**GEORGETOWN MIDDLE-HIGH SCHOOL RENOVATIONS
Georgetown, MA**

ADDENDUM NO.2

February 13, 2015

RP2-07
 Ref. Dwg. P1-1-1A

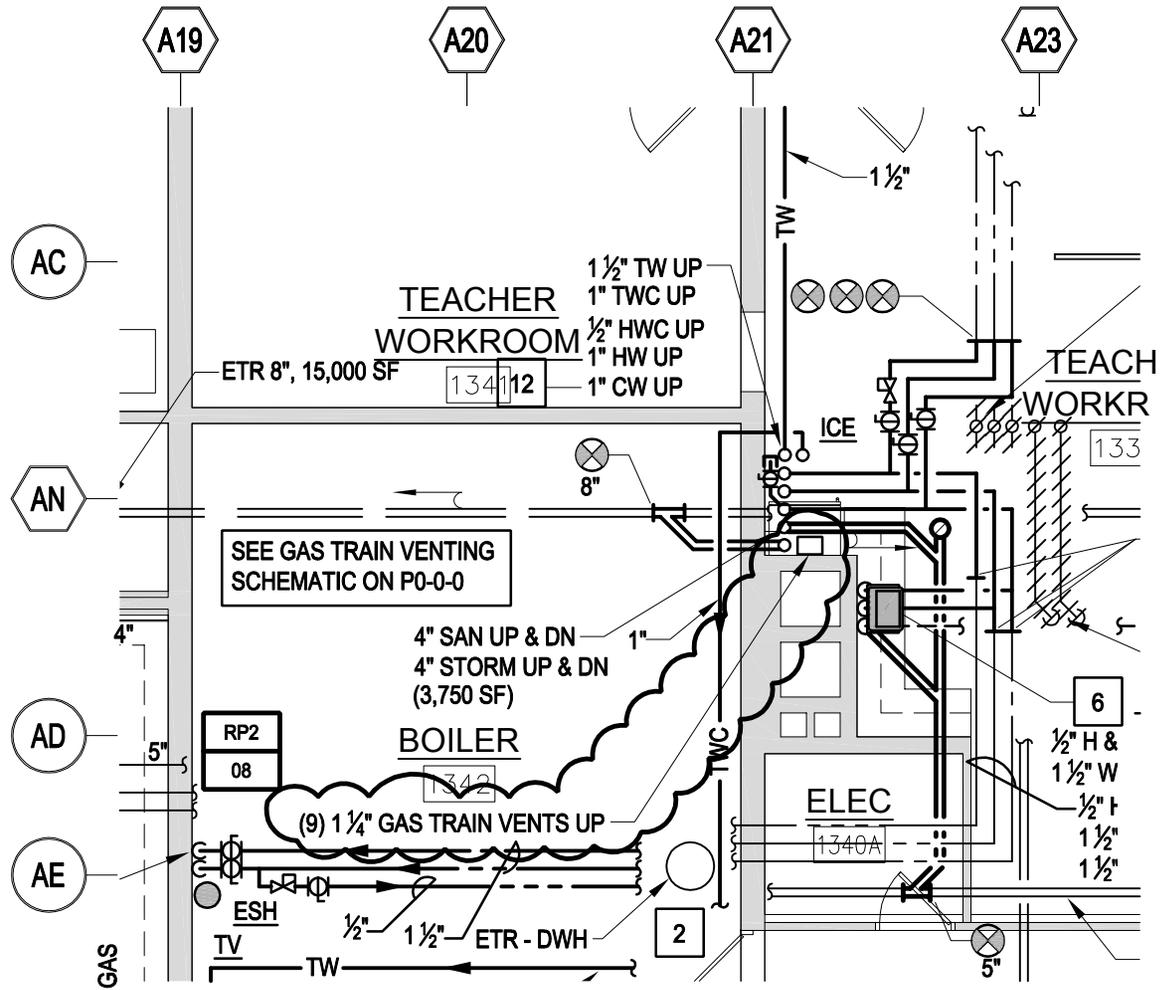
- ADD 2-37 P1-1-1A PLUMBING FIRST FLOOR PLAN AREA A**
REVISE note at existing Acid Waste Ejector. Refer to attached sketch RP2-06.
- ADD 2-38 P1-1-1A PLUMBING FIRST FLOOR PLAN AREA A**
REVISE note at existing Acid Waste Ejector. Refer to attached sketch RP2-07.

RP2-08
 Ref. Dwg. P1-1-1A

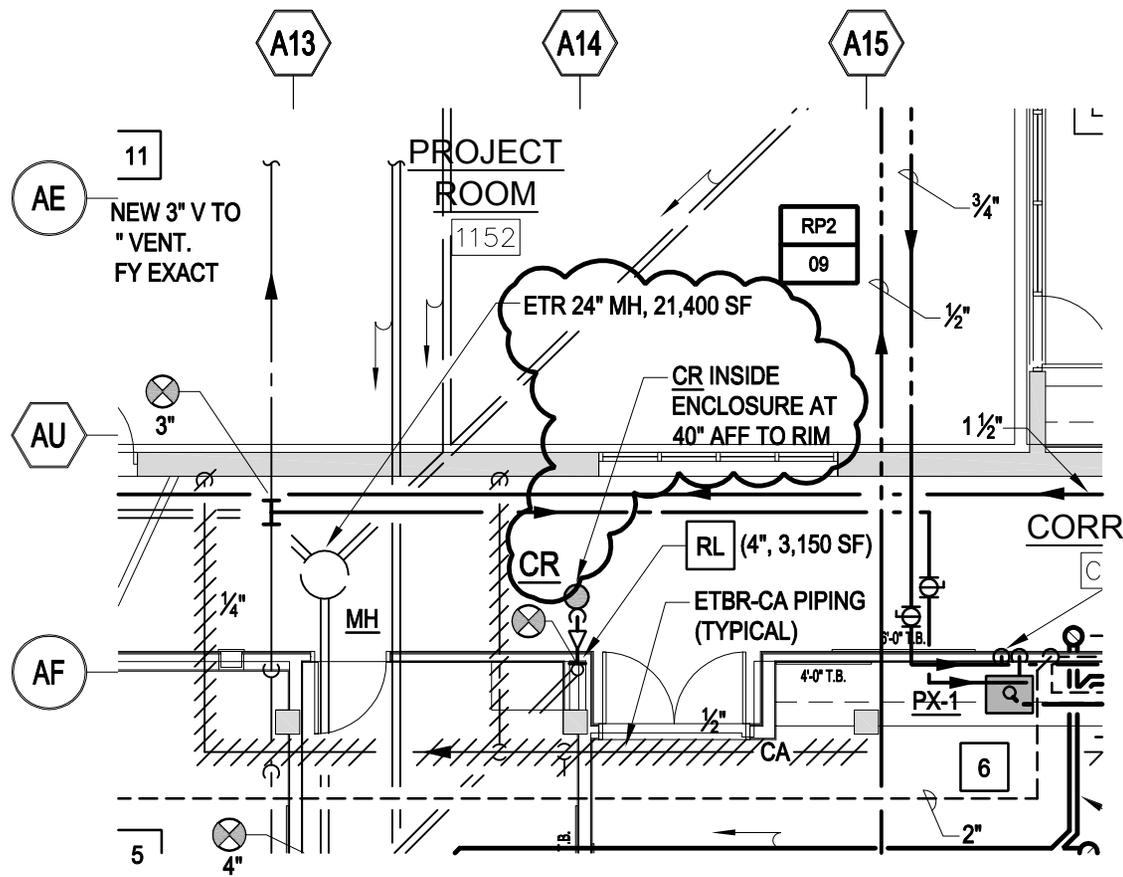
- ADD 2-39 P1-1-1A PLUMBING FIRST FLOOR PLAN AREA A**
ADD Gas Train Vents. Refer to attached sketch RP2-08.
- ADD 2-40 P1-1-1A PLUMBING FIRST FLOOR PLAN AREA A**
REVISE note at Condensate Receptor. Refer to attached sketch RP2-09.

RP2-10
Ref. Dwg. P1-1-1BC

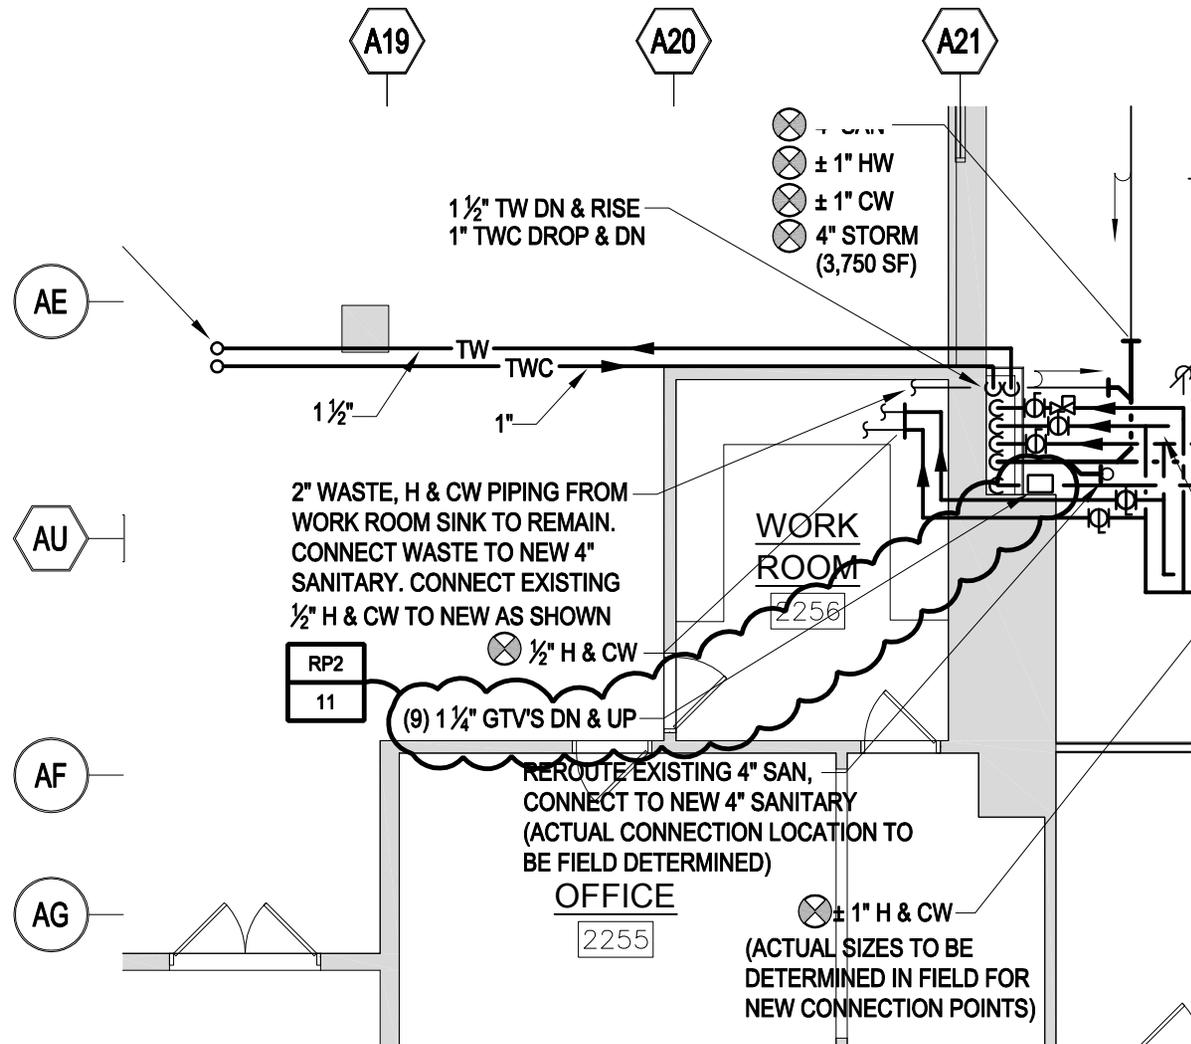
- ADD 2-41 P1-1-1BC PLUMBING FIRST FLOOR PLAN AREAS B & C**
REVISE Sump Pump Detail. Refer to attached sketch RP2-10.
- ADD 2-42 P1-1-2A PLUMBING SECOND FLOOR PLAN AREA A**
ADD Gas Train Vents. Refer to attached sketch RP2-11.

RP2-12
 Ref. Dwg. P1-1-2A

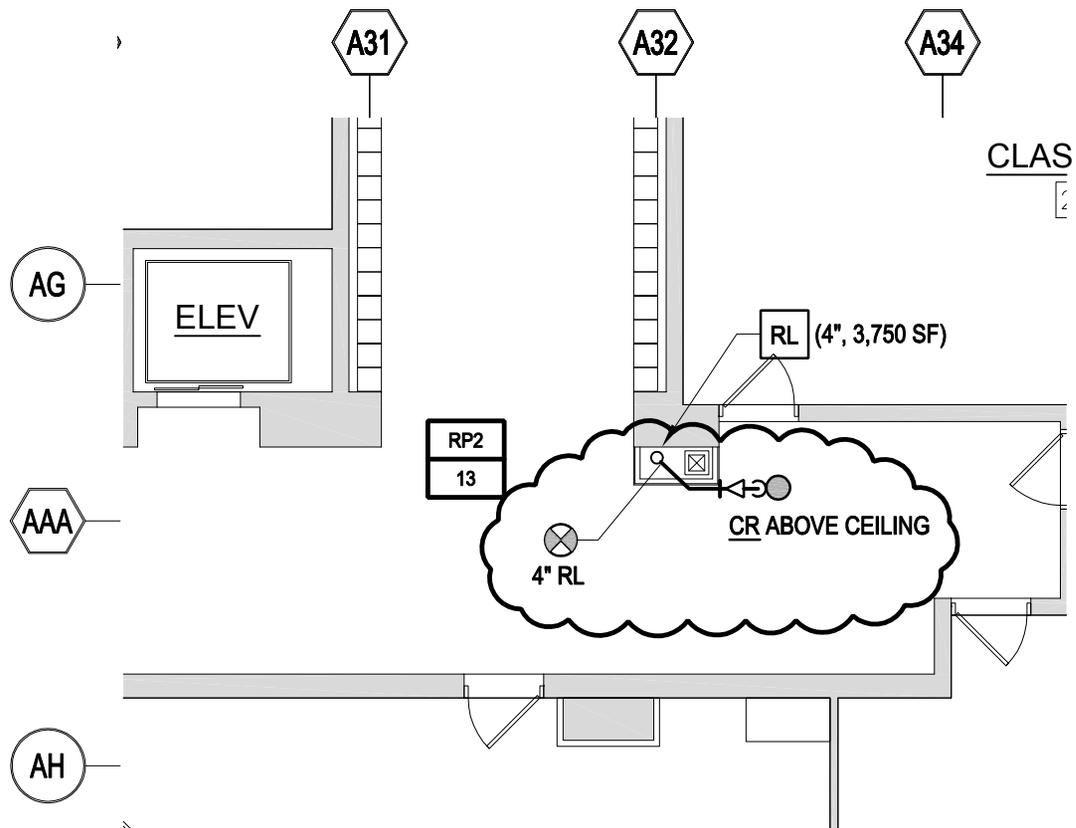
- ADD 2-43 P1-1-2A PLUMBING SECOND FLOOR PLAN AREA A**
ADD Condensate Receptor. Refer to attached sketch RP2-12.
- ADD 2-44 P1-1-2A PLUMBING SECOND FLOOR PLAN AREA A**
ADD Condensate Receptor. Refer to attached sketch RP2-13.

RP2-14
 Ref. Dwg. P1-1-3A

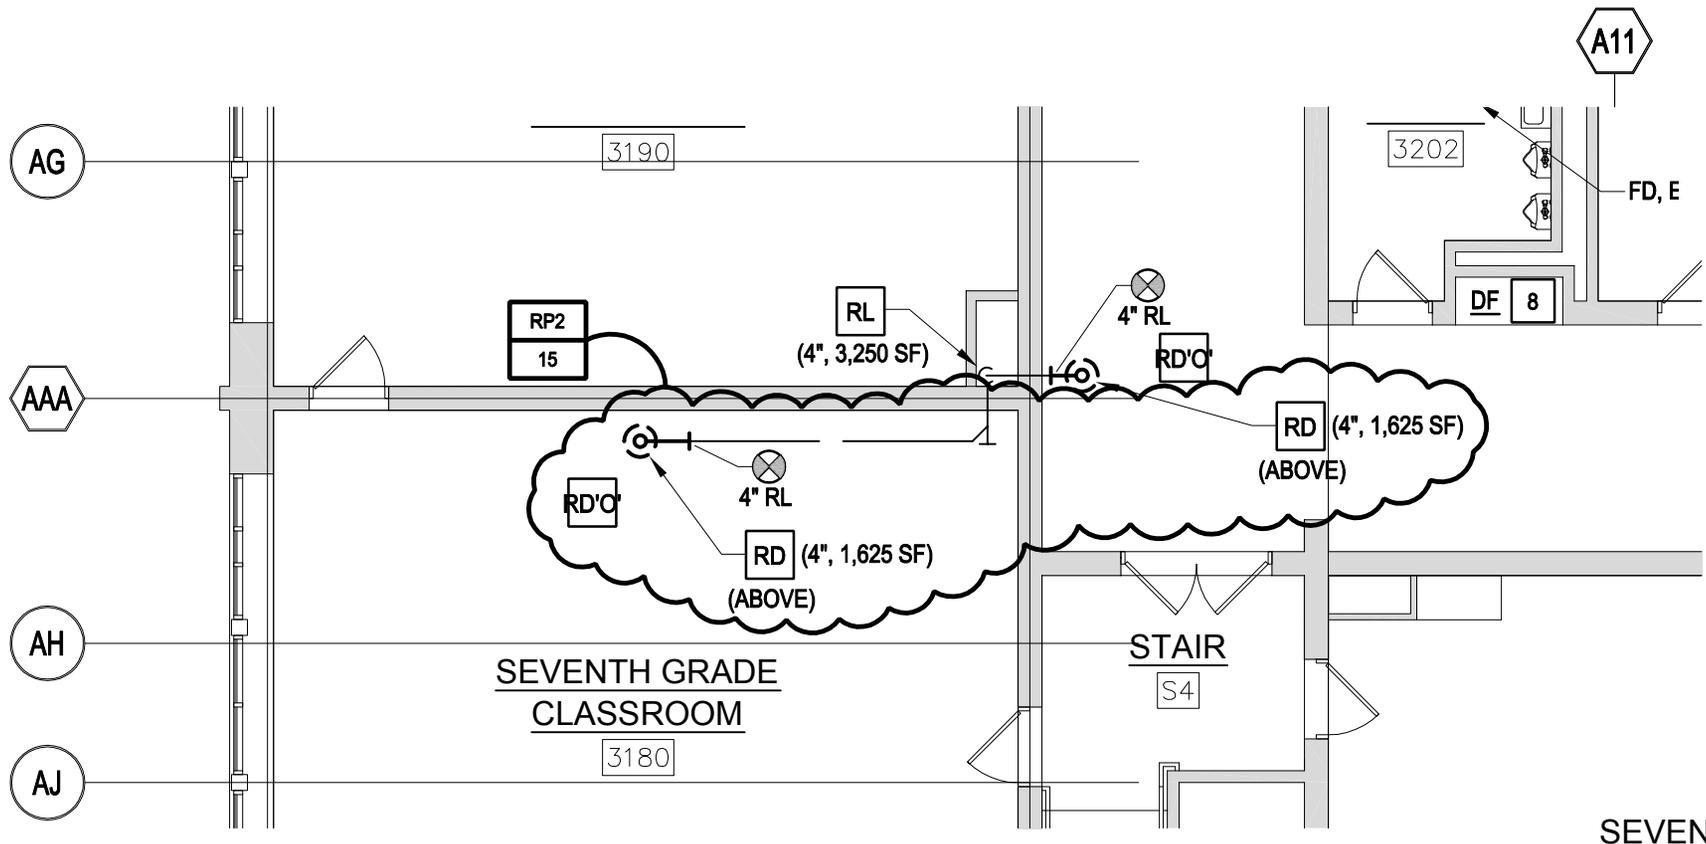
- ADD 2-45 P1-1-3A PLUMBING THIRD FLOOR PLAN AREA A**
ADD Gas Train Vents. Refer to attached sketch RP2-14.
- ADD 2-46 P1-1-3A PLUMBING THIRD FLOOR PLAN AREA A**
ADD Roof Drain. Refer to attached sketch RP2-15.

RP2-16
 Ref. Dwg. P1-1-3A

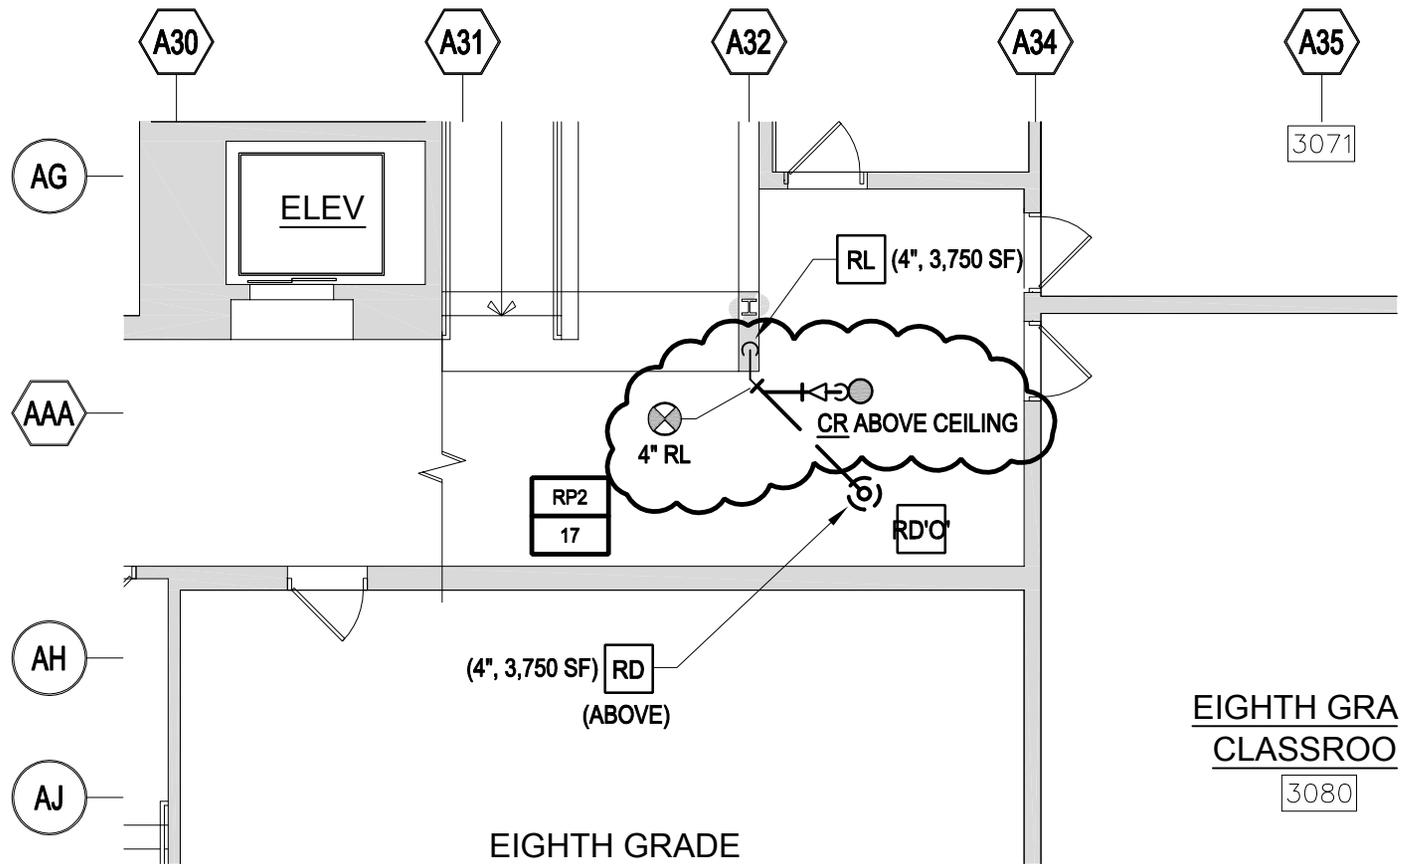
- ADD 2-47 P1-1-3A PLUMBING THIRD FLOOR PLAN AREA A**
ADD Condensate Receptor. Refer to attached sketch RP2-16.
- ADD 2-48 P1-1-3A PLUMBING THIRD FLOOR PLAN AREA A**
ADD Condensate Receptor. Refer to attached sketch RP2-17.

RP2-18
 Ref. Dwg. P1-1-4A

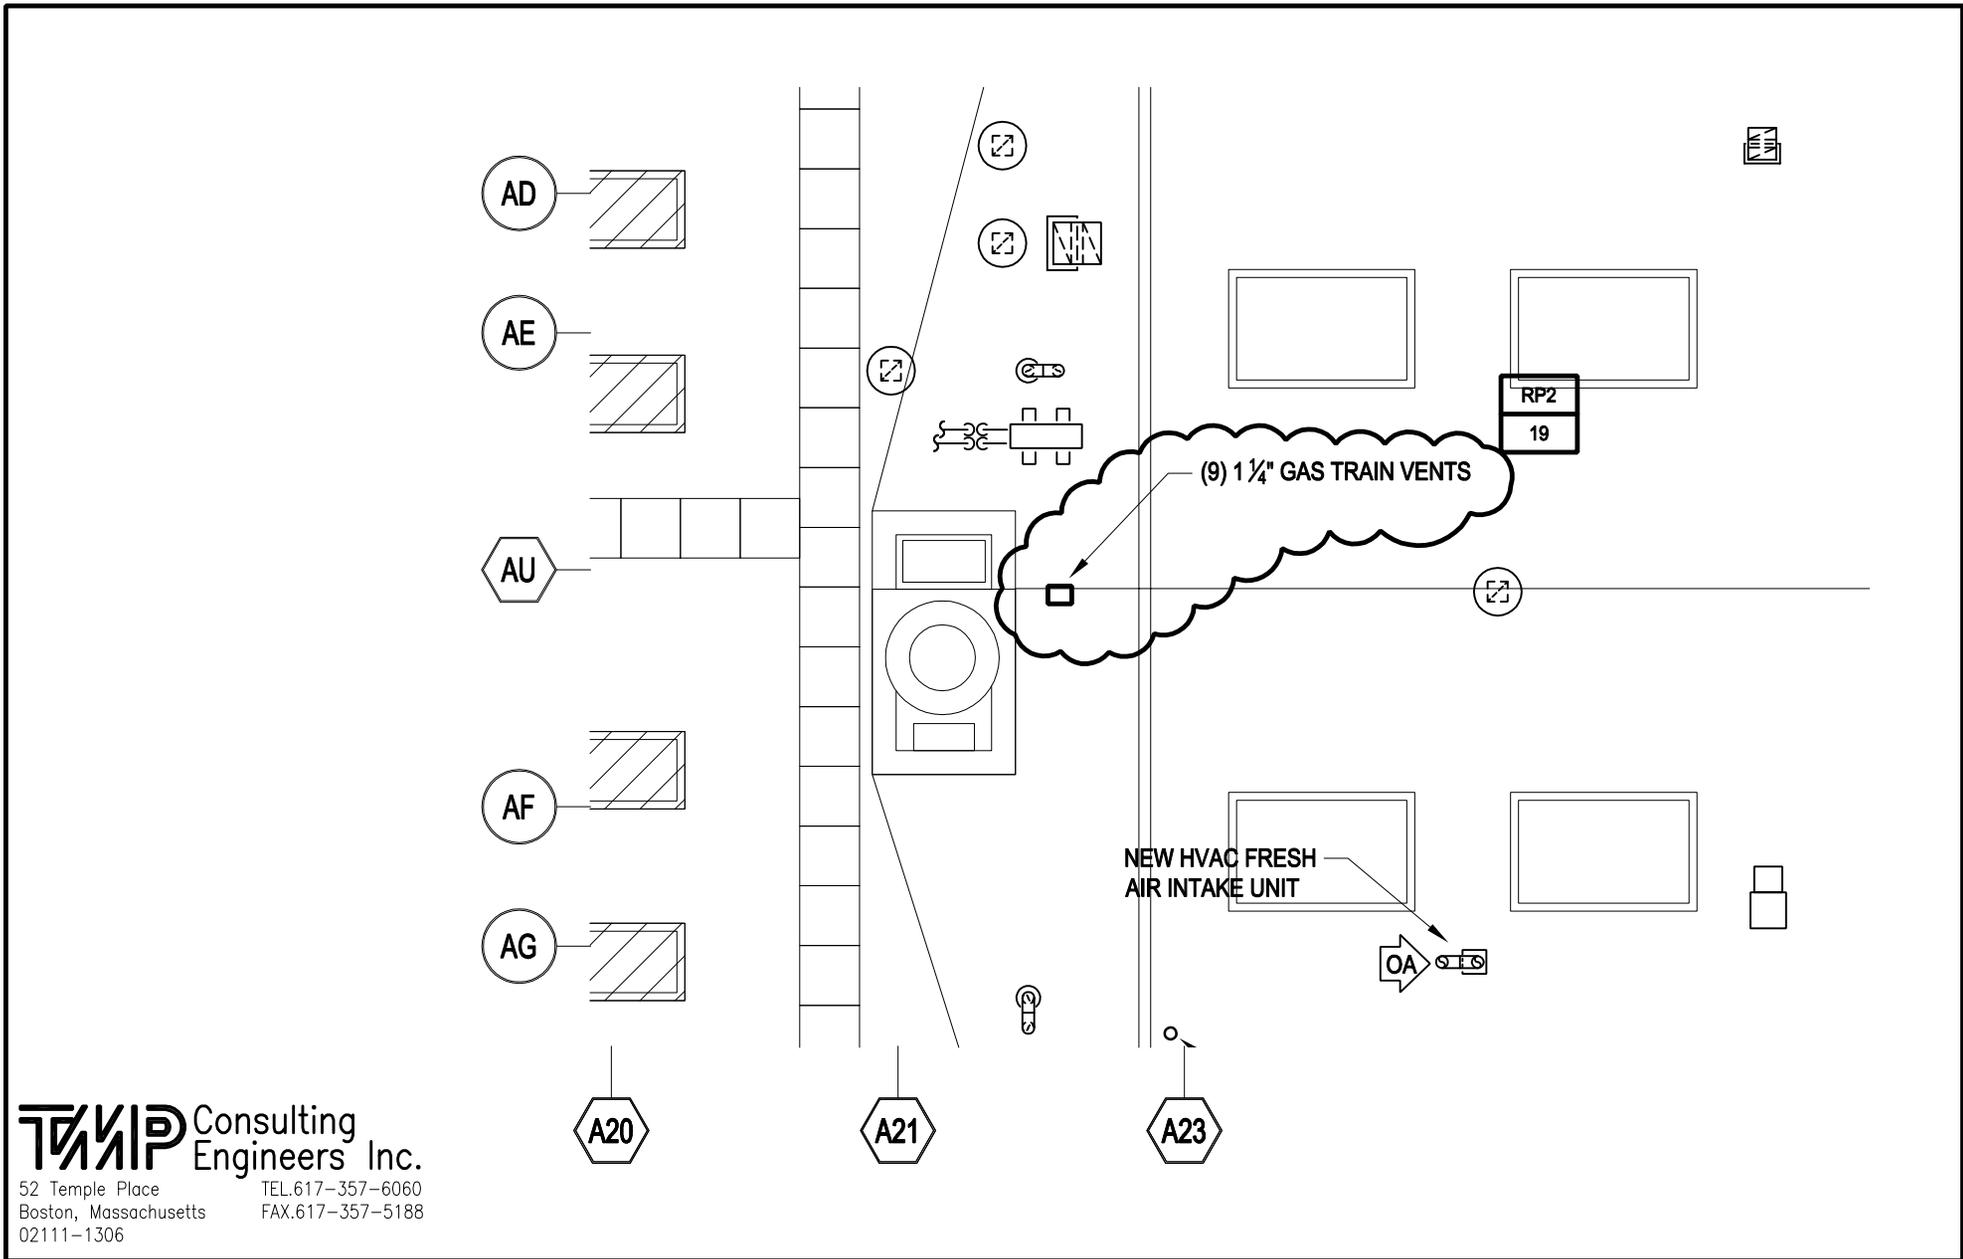
- ADD 2-49 P1-1-3A PLUMBING ROOF PLAN AREA A**
ADD Roof Drain. Refer to attached sketch RP2-18.
- ADD 2-50 P1-1-3A PLUMBING ROOF PLAN AREA A**
ADD Gas Train Vents. Refer to attached sketch RP2-19.
